PLANNING AND REGULATORY FRAMEWORK: Sector Plan

Compliance With The 1994 Sector Plan:

Community-Based Planning supports the project and its proposed amenity package with the exception of its height and recommends approval of the Air Rights Hotel project plan with a reduction in the proposed height from 116 feet to 90 feet.

6 BIKE TRAIL PLAN DETAIL
NOT TO SCALE

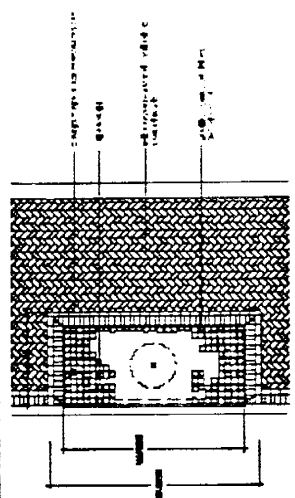
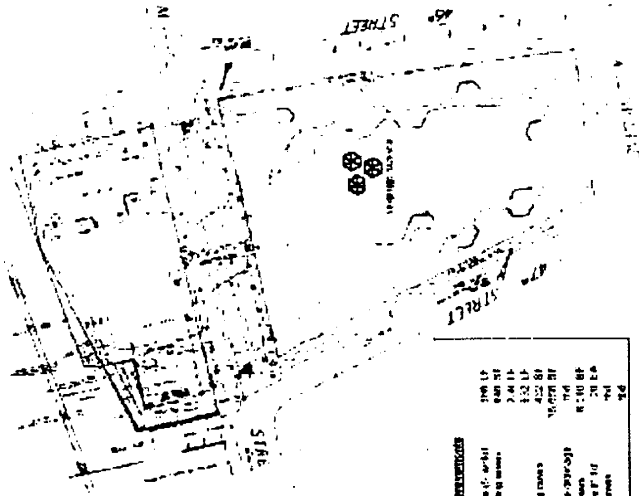
Issue: Bike Path Connection through Pearl Street ROW.

The 1994 Sector Plan recommended the Pearl Street Bike Path be connected to the interim Capital Crescent Trail with Stage Two Facility Improvements. Bethesda is now within Stage Two. The staff of MCDPWT have been developing a strategy with the adjacent landowner, Robert Eisinger who would grant an easement to allow the bike path connection (a staircase and bike carry ramp) through his property to the interim Capital Crescent Trail.

Applicant's position: As part of the off site amenity package for this Project Plan, the applicant will build the bike path connection steps and bike ramp. They propose to locate the connector with minimal disturbance to existing conditions and to construct it from wood, given the interim nature of the Capital Crescent Trail.

Staff's position: Support the trail connection with this application. The Developer relies on MCDPWT to obtain the easement onto which they can build the bike ramp and stairs; we propose M-NCPPC assist in this acquisition in any way. Detailed arrangements for the design, materials and related area improvements (drainage improvements, review of retaining wall status) will be reviewed with the future site plan proposal. The implementation of this path connection will be reviewed at site plan approval.
